SUBMISSIONS REPORT

104-116 Regent Street,
Redfern

15 June 2022

Table 4 Response to Department of Planning Submission

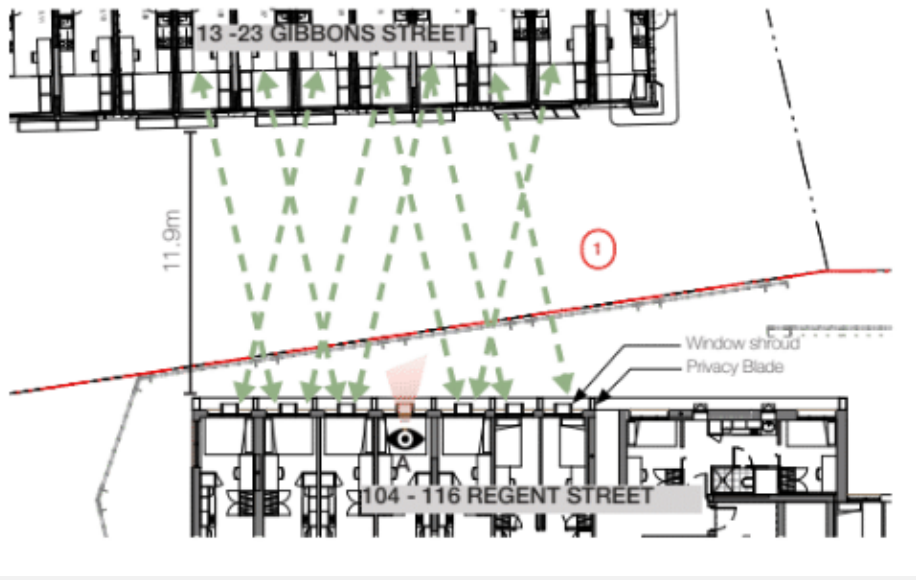
Item	Issue	Response
Building Height	Reduce the height of the building to comply with the 18-storey height limit (noting the proposal currently reads as a 19-storey building) and ensure roof top plant is integrated into the design of the building or appropriately screened.	<p>Significant changes have been made to the siting and design of the roof-top plant and equipment to minimise potential visual impact and avoid the perception of this forming an additional storey. The proposed changes include:</p> <ul style="list-style-type: none">▪ The rooftop plant is setback from the perimeter.▪ The parapet height reduced from 3.55m to 1.5m.▪ Metal louvre screens have been included around the equipment to conceal the visible portion of the plant equipment behind. <p>The revised design is shown on Page 2 of the Design Report at Appendix C.</p> <p>The proposed amendments have sought to reduce the bulk and minimise the visual impact of the roof top plant. The revised proposal has a maximum building height of RL85.1 (a reduction from RL 87.15). Further, the height of the tower is now lower than the adjoining building to the north at 90-102 Regent Street.</p>

Height transition to heritage listed church	Reconsider the height of the shorter tower element to provide an improved height transition to the Heritage listed church	<p>The tower massing of the southern tower decreases in scale to signify the end of the transitional precinct. The southern tower is 15 storeys with an open roof top communal space positioned on Level 16, providing a more compatible massing relationship with the podium and northern tower form.</p>

Item	Issue	Response
		<p>Antoniades Architects explored the options of a shorter, wider tower as part of the State Design Review Panel (SDRP) meeting process. However, it was concluded the reduced south tower height would result in a disproportionate outcome as shown in the extract below.</p>  <p>The proposed south tower height and massing creates a compatible pattern in the overall transitional context along the streetscape. The slender tower form creates a preferred design outcome compared to a shorter, wider tower. Accordingly, no changes are proposed to the southern tower form and height. It is considered the southern tower creates an appropriate transition outcome between the taller northern tower form and the 2-3 storey podium. The proposed podium design has been revised to step down to relate to the Regent Street topography and to St Luke's Presbyterian Church.</p>

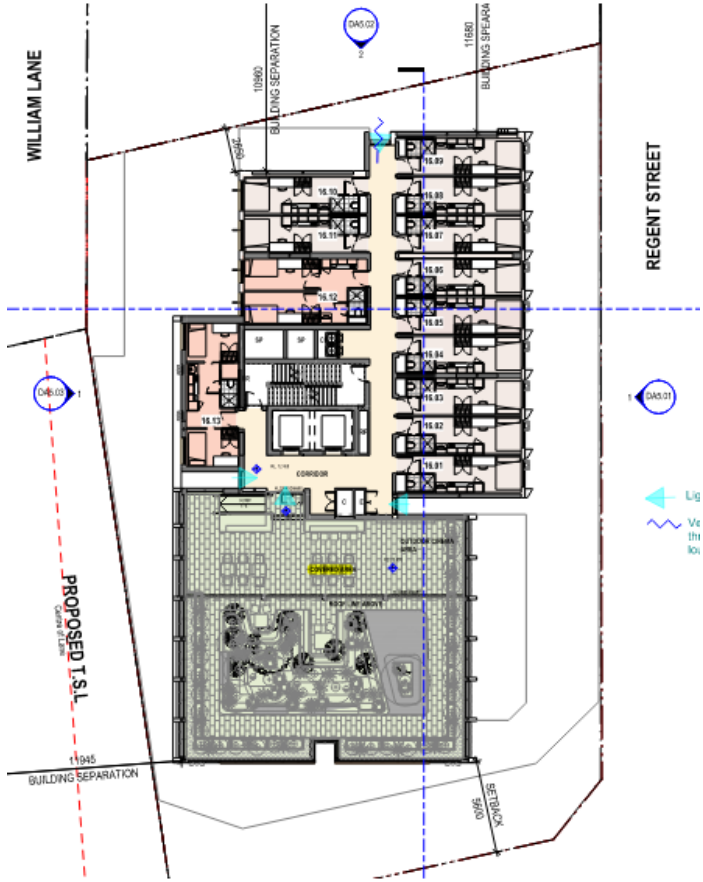
Item	Issue	Response
Ventilation	<p>The design development of the non-mechanical ventilation system remains unconvincing since SDRP proposal for a ceiling plenum to attenuate traffic noise. It is unclear from the design report if this is still being considered, barriers to achieving the SDRP proposal from recent precedent in the City of Sydney (CoS) LGA include:</p> <ul style="list-style-type: none"> a. the proposed 3100mm floor to floor height b. augmentation with vertical plenums; that will significantly impact the spatial planning of individual dwellings. <p>GANSW recommends that CoS advice in this regard be sought, as they are leading the government expertise in this space. The EIS approach cannot be supported without further evidence of balancing noise with ventilation.</p>	<p>Vipac Engineers have prepared an updated statement (Appendix H) which confirms all rooms are supplied with air-conditioning and ducted ventilation.</p> <p>Opportunities for natural ventilation are limited due to the acoustic impacts of Regent Street, therefore ducted ventilation is provided to ensure occupants' comfort and access to fresh air.</p>

Item	Issue	Response
		<p>Antoniades Architects have reconfigured the services risers and cupboards to allow light from the east and west frontages.</p> <p>Refer to Amended Architectural Plans (Appendix B) and the plan extract below which shows Level 16 with the light access shown in light blue.</p>
